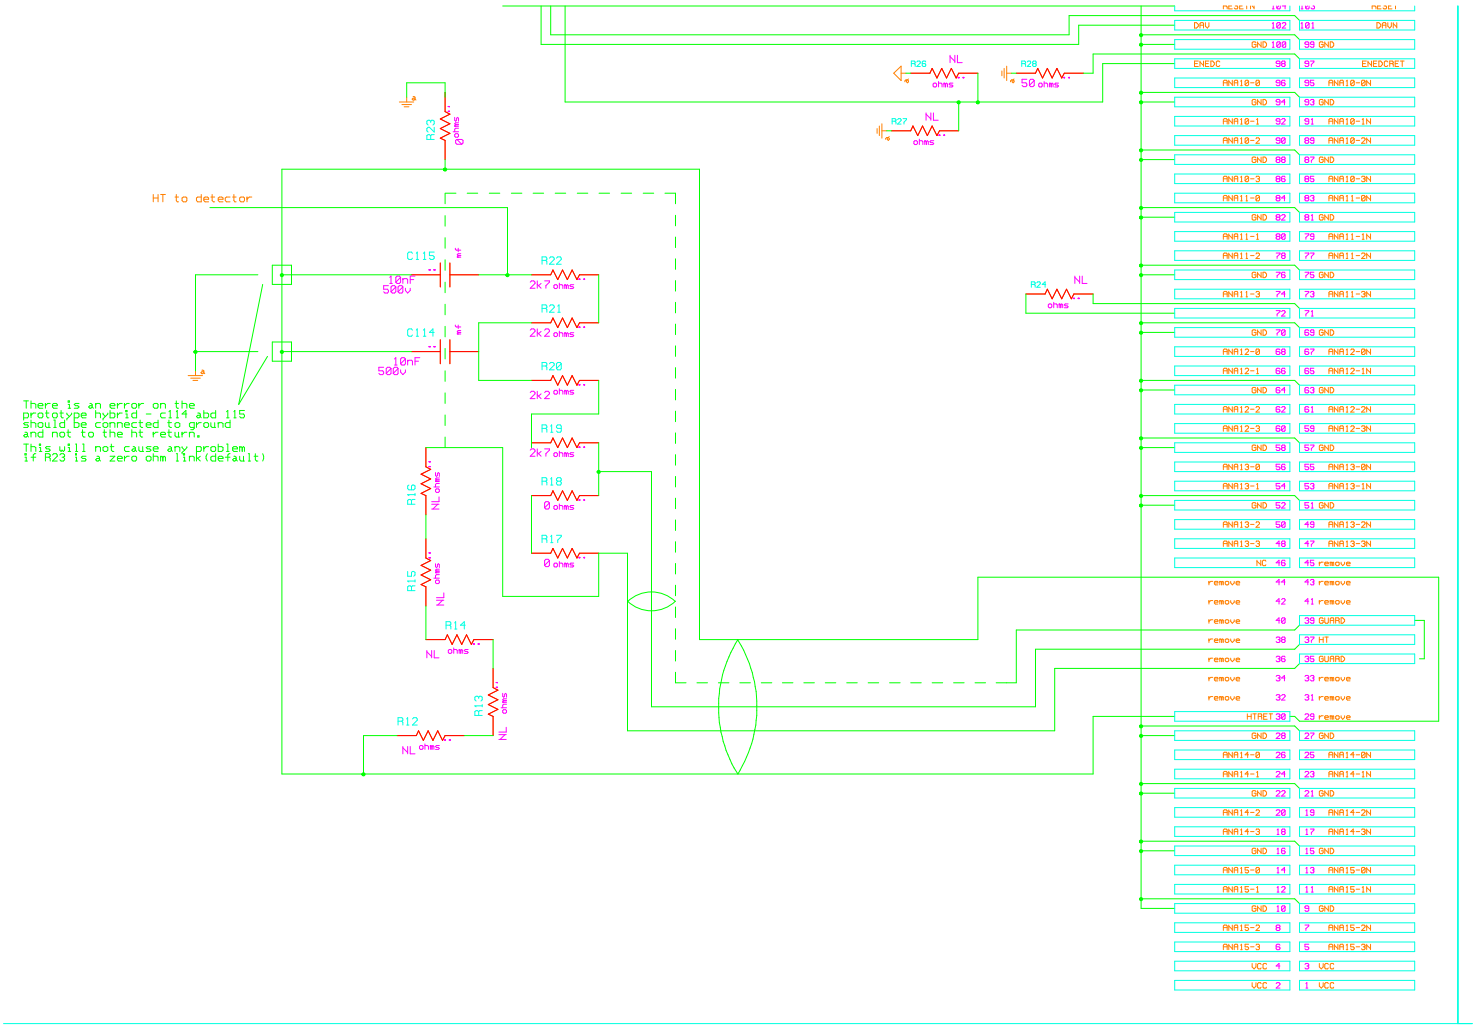
HT to detector
R23 0 ohms
C115 10nF 500v
C114 10nF 500v
R22 2k7 ohms
R21 2k2 ohms
R20 2k2 ohms
R19 2k7 ohms
R18 0 ohms
R17 0 ohms
R16 NL ohms
R15 NL ohms
R14 NL ohms
R13 NL ohms
R12 NL ohms
R26 NL ohms
R28 50 ohms
R27 NL ohms
R24 NL ohms
There is an error on the prototype hybrid - c114 abd 115 should be connected to ground and not to the ht return.
This will not cause any problem if R23 is a zero ohm link(default)
DAV 102 101 DAVN
GND 100 99 GND
ENEDC 98 97 ENEDCRET
ANA10-0 96 95 ANA10-0N
GND 94 93 GND
ANA10-1 92 91 ANA10-1N
ANA10-2 90 89 ANA10-2N
GND 88 87 GND
ANA10-3 86 85 ANA10-3N
ANA11-0 84 83 ANA11-0N
GND 82 81 GND
ANA11-1 80 79 ANA11-1N
ANA11-2 78 77 ANA11-2N
GND 76 75 GND
ANA11-3 74 73 ANA11-3N
72 71
GND 70 69 GND
ANA12-0 68 67 ANA12-0N
ANA12-1 66 65 ANA12-1N
GND 64 63 GND
ANA12-2 62 61 ANA12-2N
ANA12-3 60 59 ANA12-3N
GND 58 57 GND
ANA13-0 56 55 ANA13-0N
ANA13-1 54 53 ANA13-1N
GND 52 51 GND
ANA13-2 50 49 ANA13-2N
ANA13-3 48 47 ANA13-3N

NC 46 45 remove
remove 44 43 remove
remove 42 41 remove
remove 40 39 GUARD
remove 38 37 HT
remove 36 35 GUARD
remove 34 33 remove
remove 32 31 remove
HTRET 30 29 remove
GND 28 27 GND
ANA14-0 26 25 ANA14-0N
ANA14-1 24 23 ANA14-1N
GND 22 21 GND
ANA14-2 20 19 ANA14-2N
ANA14-3 18 17 ANA14-3N
GND 16 15 GND
ANA15-0 14 13 ANA15-0N
ANA15-1 12 11 ANA15-1N
GND 10 9 GND
ANA15-2 8 7 ANA15-2N
ANA15-3 6 5 ANA15-3N
VCC 4 3 VCC
VCC 2 1 VCC
